WORK TO BE ADDED TO CONTRACT # 62105

REVISIONS		ILLINOIS DEPARTMENT OF TRANSPORTATION F.A.I. ROUTE 80/94 (INTERSTATE 80/294) BOX CULVERT STAGING PLAN STA. 31+327.73 (194 WB) TO STA. 218+879.08 (RAMP V) STRUCTURE NO. 016-C009 DESIGNED BY JCE DRAWN BY JCE DATE: July 8, 2004 CHECKED BY JCA CHECKED BY JCA
NAME	DATE	
ADDENDUM #1	12/29/05

BC - 2

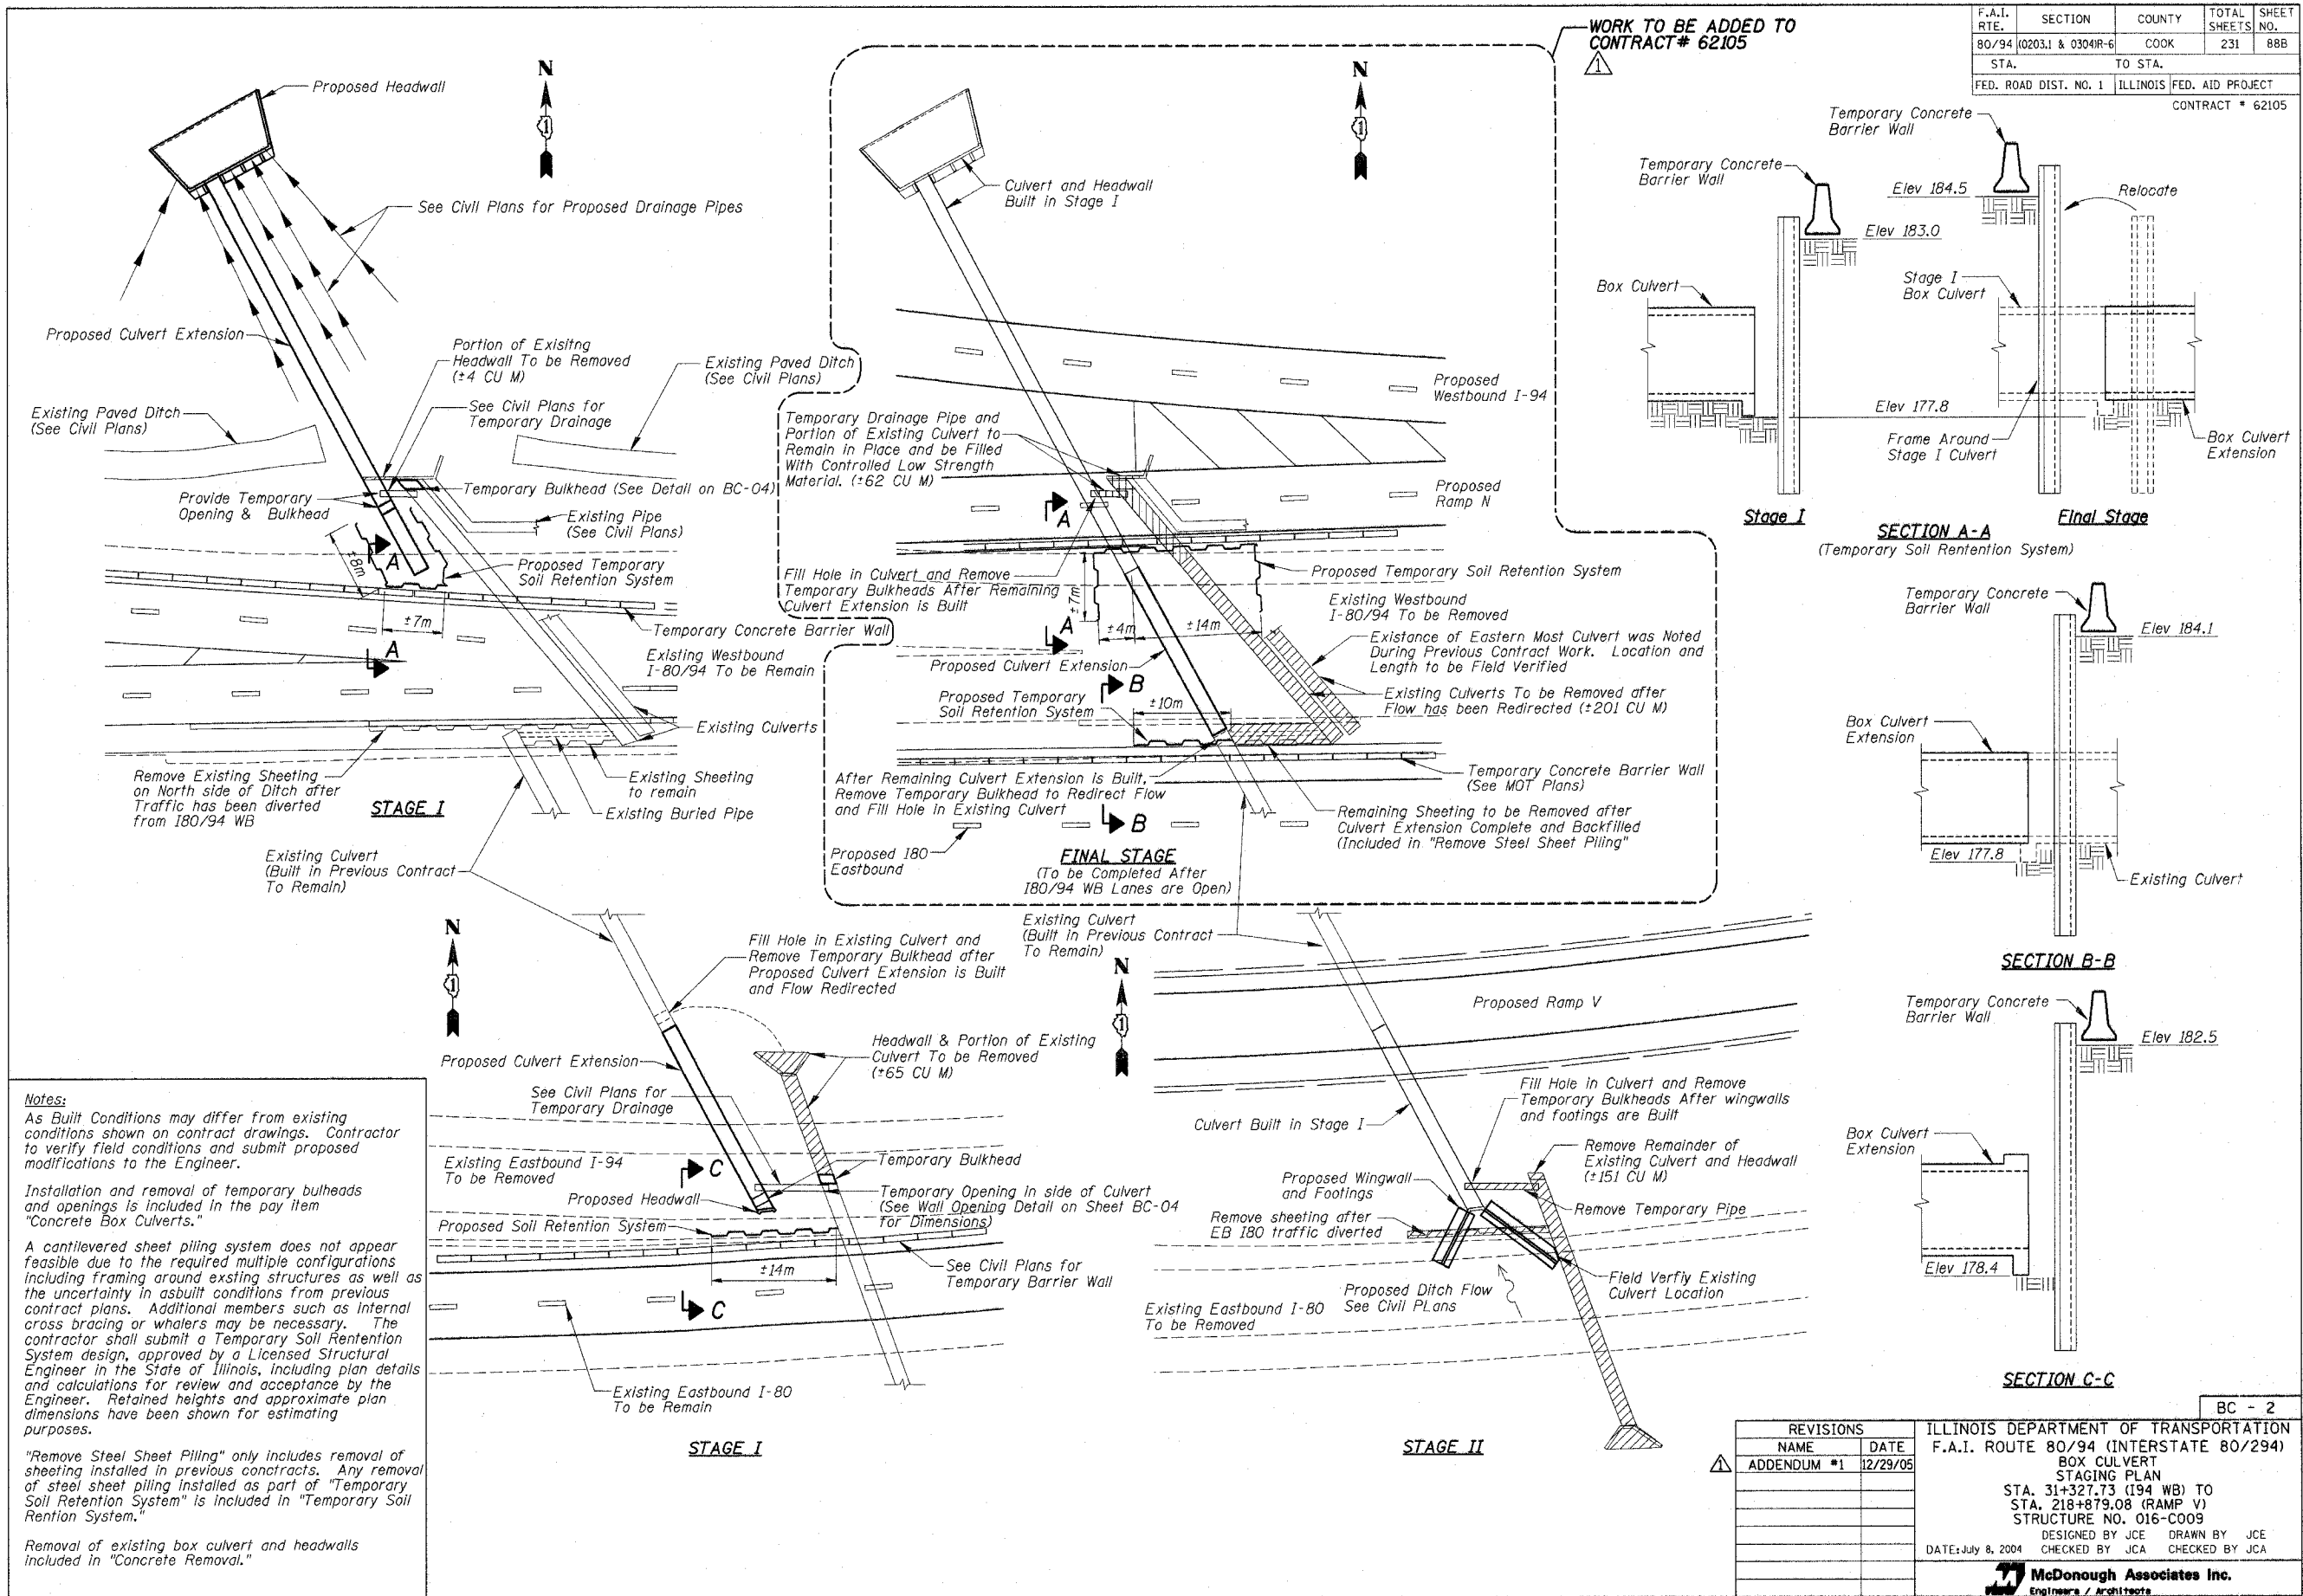
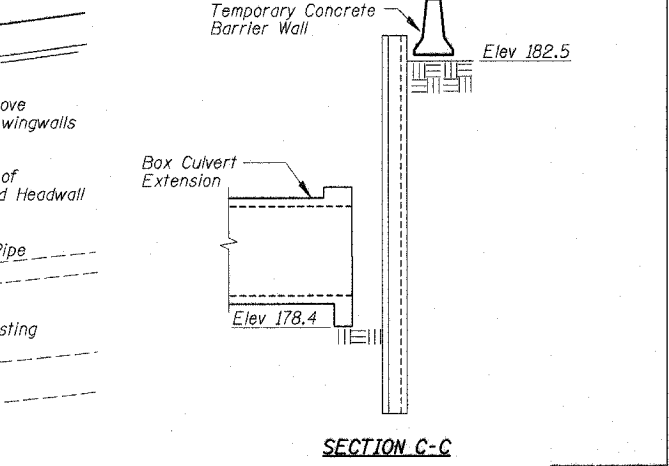
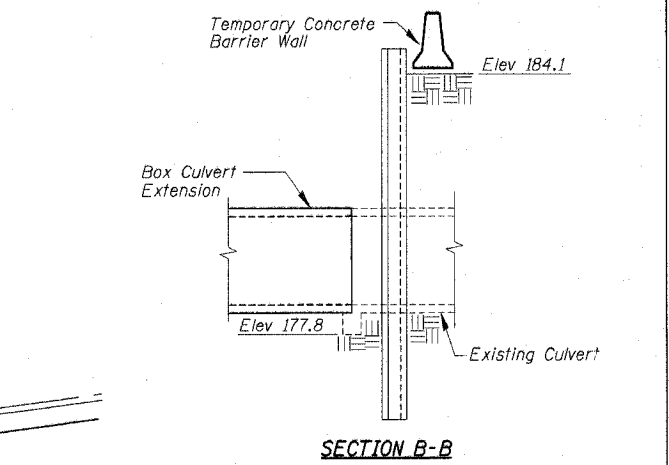
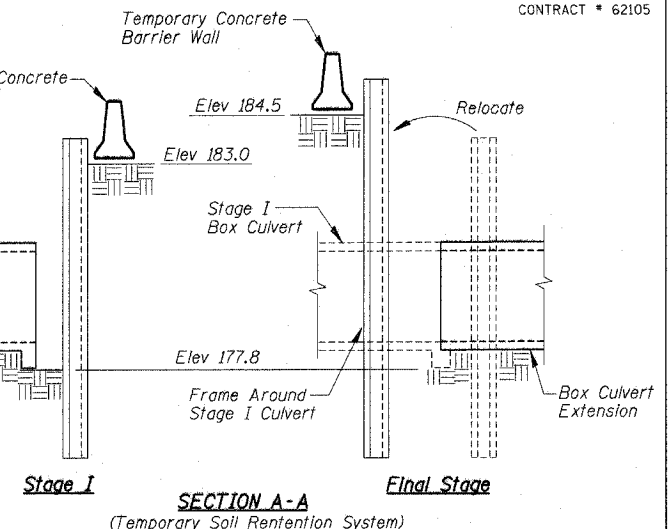
Notes:
 As Built Conditions may differ from existing conditions shown on contract drawings. Contractor to verify field conditions and submit proposed modifications to the Engineer.
 Installation and removal of temporary bulheads and openings is included in the pay item "Concrete Box Culverts."
 A cantilevered sheet piling system does not appear feasible due to the required multiple configurations including framing around existing structures as well as the uncertainty in asbuilt conditions from previous contract plans. Additional members such as internal cross bracing or walers may be necessary. The contractor shall submit a Temporary Soil Retention System design, approved by a Licensed Structural Engineer in the State of Illinois, including plan details and calculations for review and acceptance by the Engineer. Retained heights and approximate plan dimensions have been shown for estimating purposes.

"Remove Steel Sheet Piling" only includes removal of sheeting installed in previous contracts. Any removal of steel sheet piling installed as part of "Temporary Soil Retention System" is included in "Temporary Soil Retention System."
 Removal of existing box culvert and headwalls included in "Concrete Removal."
